**CITY OF GRANT
PLANNING COMMISSION MEETING**

Tuesday, March 20, 2018

STAFF REPORT

RE: Application for Minor Subdivision
11425 & 11335 Grenelefe Avenue
North, Grant, MN

PROJECT-PAGE TITLE
 PROPERTY MAP

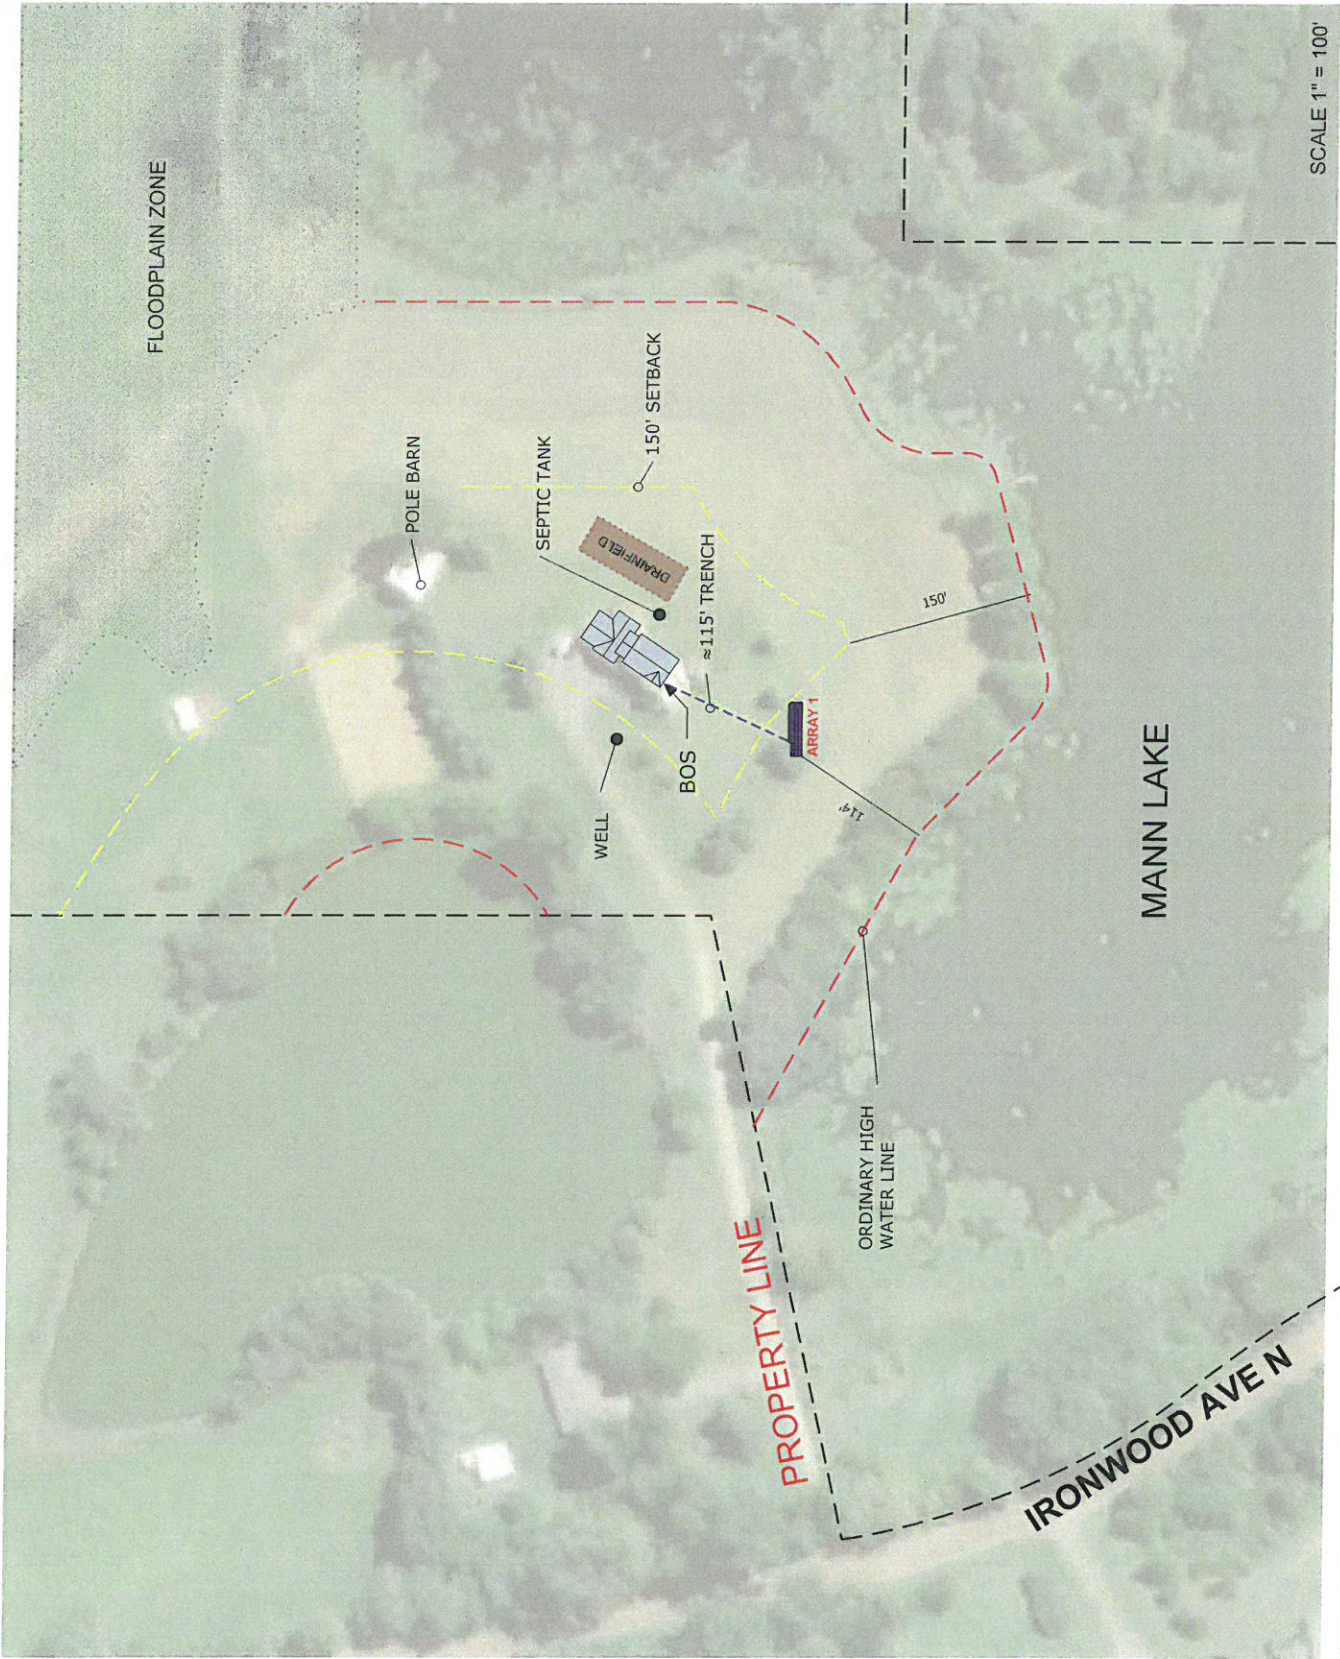
Standard	Required	Proposed	Variance	Description
OHWL	200' (structures)	114' +/-	86' +/-	The Applicant's site plan identifies the OHWL which is denoted with a red dotted line. It is unclear the source of the information to determine the OHWL. Additionally, the Applicant identified a 150-foot setback which is denoted with a yellow dashed line. The City's ordinance identifies a 200-foot setback, so this line would need to be adjusted and resubmitted for evaluation.

Based on the information submitted, it is difficult to determine whether there are additional/alternate site locations that could support the proposed structure outside of applicable setbacks because the site plan does not denote the setback accurately. Additionally, no source was provided to the OHWL, and it is unclear what information was used to establish the boundary. As such, staff would recommend that an updated site plan be prepared if the Planning Commission considers recommendation of the variance to accurately demonstrate the encroachment. Regardless of the site plan, the lot is approximately 28 acres and based on the scale of the proposed solar array as shown on the site plan there appears to be enough area outside of setbacks where the ground mounted solar system could be constructed. To provide additional clarity, staff researched the FEMA flood zone areas as well as the National Wetland Inventory to determine the extent of the impact on the site based on those data sources (See Attachments B and C). As shown on the maps, there appears to be significant areas outside of the designated floodplain and wetland area. In addition, the Applicant noted the presence of underground systems/utilities which staff assumes is the septic system and drainfields. While this does occupy a significant portion of the upland/buildable area, staff believes there still remains area outside of setbacks that would not conflict with the septic system. Since this analysis is completed without the benefit of an updated site plan, if the Applicant can demonstrate that this analysis is inaccurate then staff would recommend an exhibit be prepared that demonstrates the constraints and provides proper source data so that the information can be verified.

- Recommend approval of the requested variance with findings and conditions.
- Table the action and request additional information from the Applicant. If the Planning Commission requests additional information, staff would request, at a minimum the following:
 - Updated site plan to reflect appropriate setback
 - Alternate locations considered, and corresponding site impacts/considerations
 - Visual Analysis to include cross sections demonstrating impact of existing location, and alternates considered
 - Updated narrative describing how the encroachment is in harmony with the intent and purpose of Article VII. Shoreland Zoning and Protection, Chapter 12.

SYSTEM DETAILS

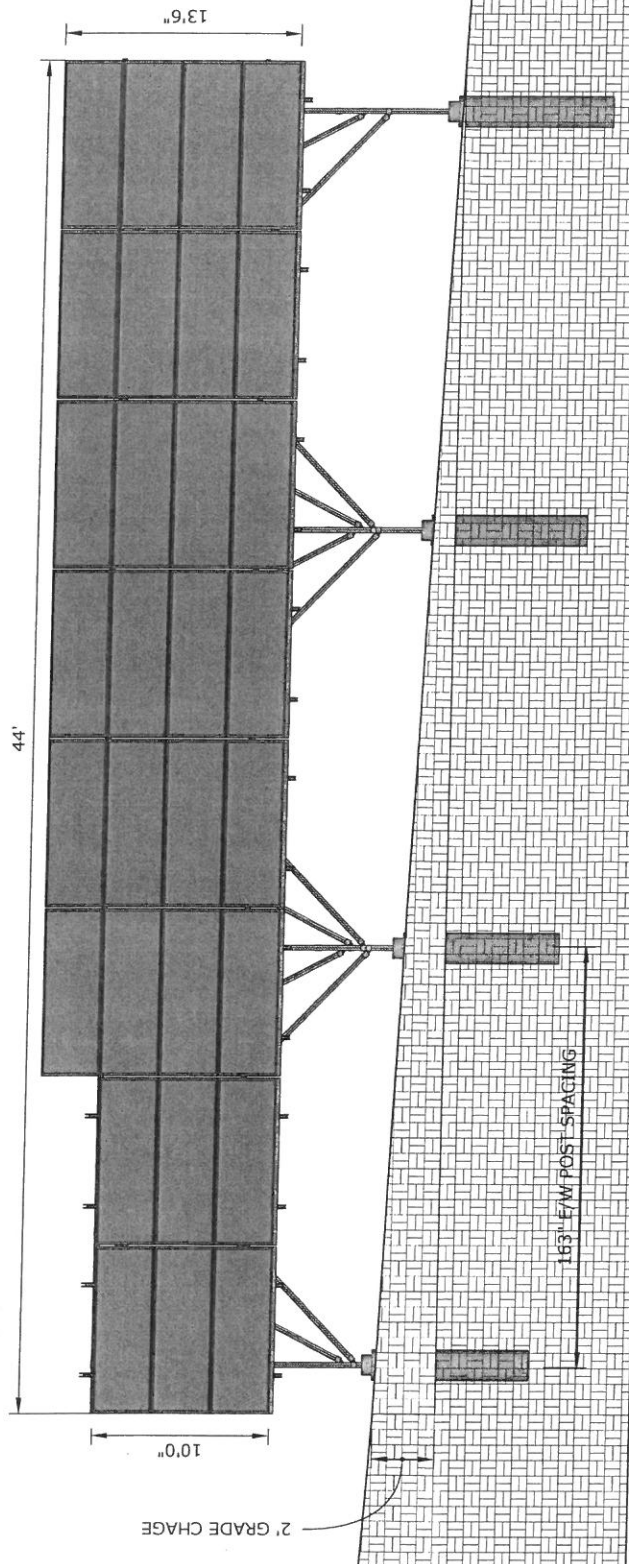
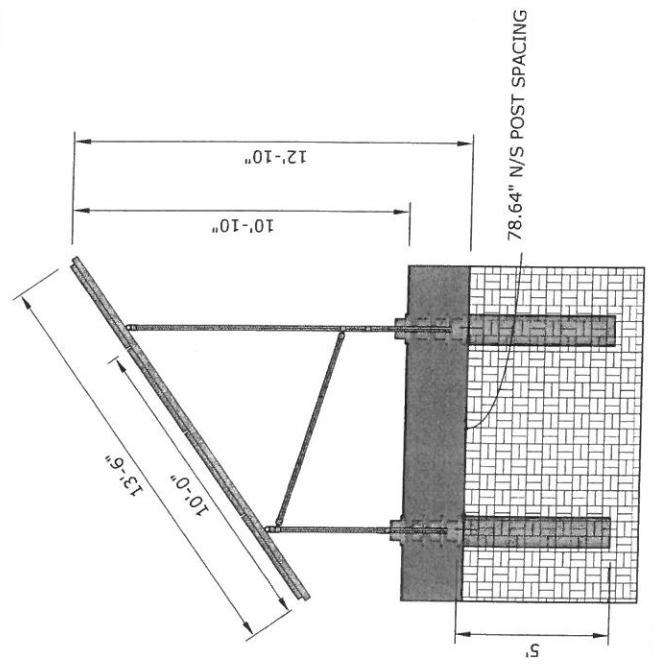
As shown in the submitted plan set it appears that the maximum height of the system is 12'10". The Applicant should confirm that this is the maximum tilt and represents the maximum height.
